# 19-01 ISSUE FOR TECHNICAL REVIEW AND ADVISORY PANEL CONSIDERATION

**Subject: Nitrogen-Reducing Media Lined Drainfields**

**Rule Sections: 64E.009**

TRAP 19-01

Figure 1. INRB media layer system

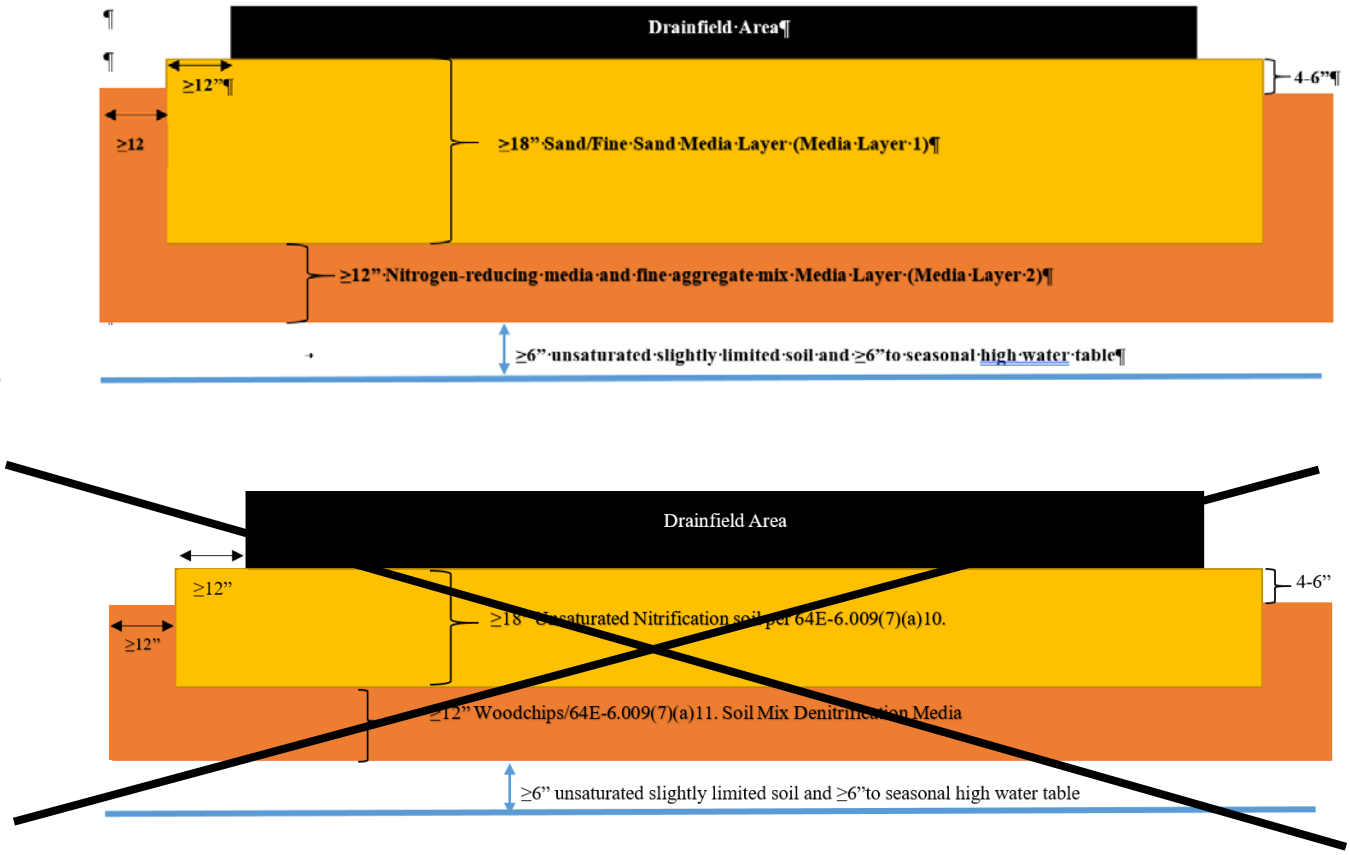
(a) INRB ~~Nitrogen-reducing media~~ layers shall be installed as follows:

1. This layer described in this subparagraph shall also be referred to as media layer one. The drainfield shall be installed centered over sand fill material that is at least 18 inches thick and conforms to the textures and colors in subparagraph 10. below. Media layer one ~~and~~ shall extend at least one foot beyond the perimeter of the drainfield. ~~The drainfield shall be centered above the sand fill area.~~

2. Below media layer one ~~the sand fill material layer required in subparagraph 1. above~~ there shall be a nitrogen-reducing media and fine aggregate mix media layer, also referred to as media layer two, that is at least 12 inches thick and extends beneath the entire drainfield absorption surface and extends at least 24 inches beyond the perimeter of any portion of the drainfield absorption surface and any other effluent release point. ~~The~~ M~~m~~edia layer two shall also extend upward along the boundary of media layer one ~~the sand fill material~~ to a point four to six inches below the bottom of the drainfield. Media layer one ~~The drainfield~~ shall be centered above ~~the~~ media layer two. ~~The~~ M~~m~~edia layer two shall conform with subparagraphs 8. and 11.

3. The bottom of ~~the~~ media layer two shall be at least 6 inches above the wet season water table.

Figure 2 INRB with Liner without underdrain

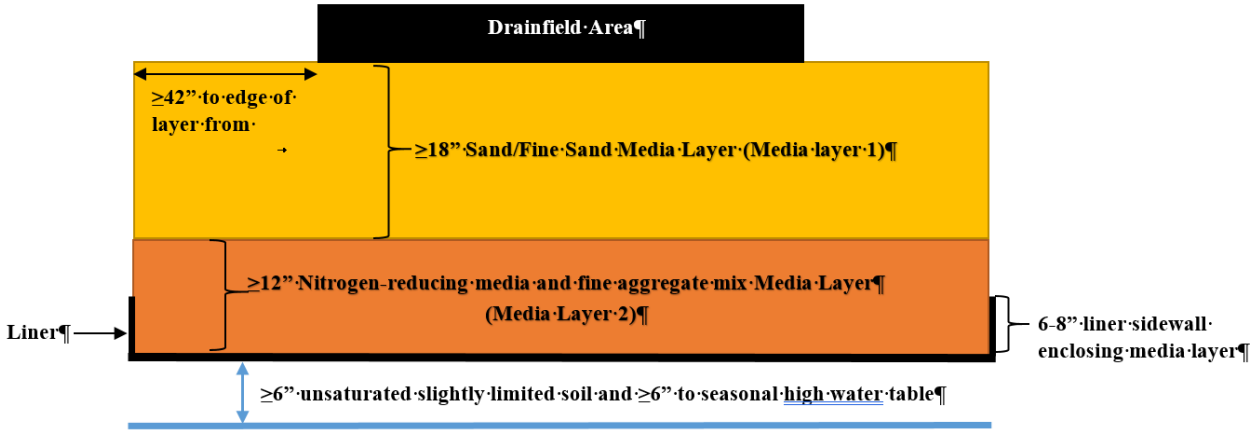
(b) INRB layers with Liner, no underdrain, shall be installed as in paragraph (a) above with the following variations:

3. Media layer two shall be enclosed beneath and on the lower 6-8 inches of all sides by an impermeable liner composed of polyvinyl chloride (PVC), high-density polyethylene (HDPE), ethylene propylene diene methylene (EPDM) or other material having a thickness of at least 30 mils and being certified by the manufacturer for a minimum lifetime of 30 years buried in contact with sewage.

4. No portion of the liner or media layer two shall be within 18 inches of the infiltrative surface of the drainfield.

5. The lowest point of the liner or media layer shall be no less than 6 inches above the water table at the wettest season of the year. There shall be at least 6 inches of unsaturated slightly limited soil between the bottom of the liner and the seasonal high water table.

Figure 3 – INRB with Liner with underdrain

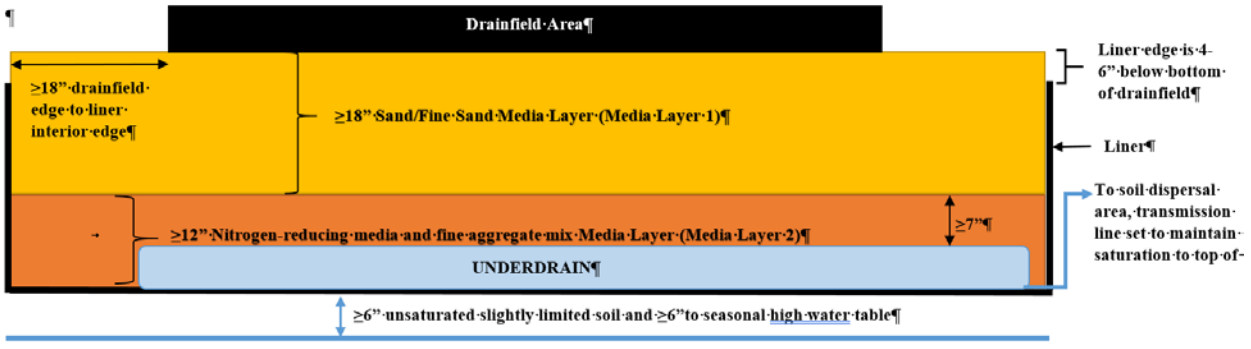
(c) INRB layers with Liner with underdrain, shall be installed as in paragraph (a) above with the following variations:

3. An impermeable liner meeting the construction standards of subparagraph (b)3., above, shall be installed below media layer two. The liner's interior surface must extend to a point at least 18 inches past the perimeter of the drainfield, at which point the liner shall be directed upwards toward the ground surface maintaining contact with media layers one and two, stopping at a point four to six inches below the level of the bottom of the drainfield. No portion of the media layer shall be less than 18 inches below the infiltrative surface of the drainfield. Media

4. An underdrain shall be installed on top of and in contact with the interior surface of the bottom of the liner within the media layer, and shall disperse to a separately sized, located and installed drainfield. The underdrain shall be designed to maximize effluent movement media layer two into the underdrain. The transmission line from the underdrain to the separate drainfield shall be set to maintain saturation to the top of the media layer. In order to maintain distribution as high as possible above the seasonal high water table and to maintain the most shallow depth to finished grade the transmission line must not have a slope exceeding 1/8 per foot when distributing the effluent to the separate drainfield.

6. The minimum thickness of media layer two as measured between the top of the underdrain and the top of the media shall be 7 inches.
